### ADDENDUM NO. 3

WCS Office Training Facility  
 2764 Commerce Rd  
 Wilson, NC 27893

WINDOW IN RANGE CONTROL:

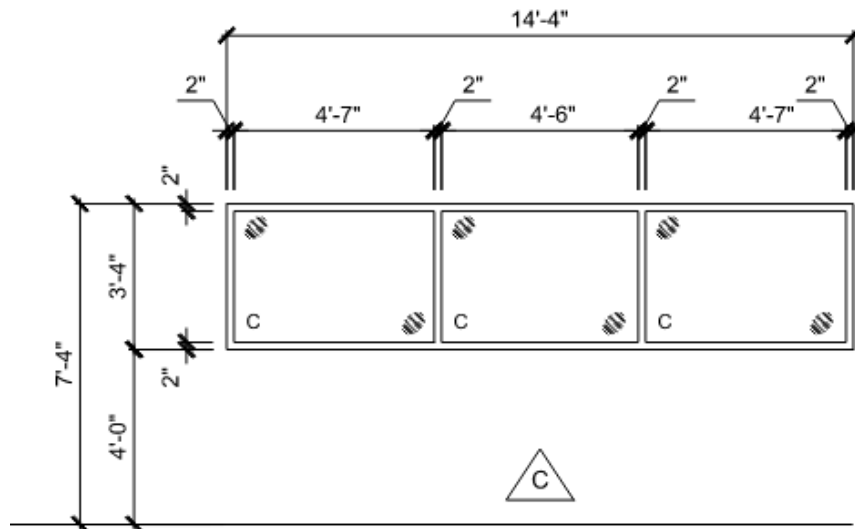
- 1 Omit Glass in window "C", shown below; 16 Gauge Hollow Metal framed opening only. Rating not required until future gun range upfit.
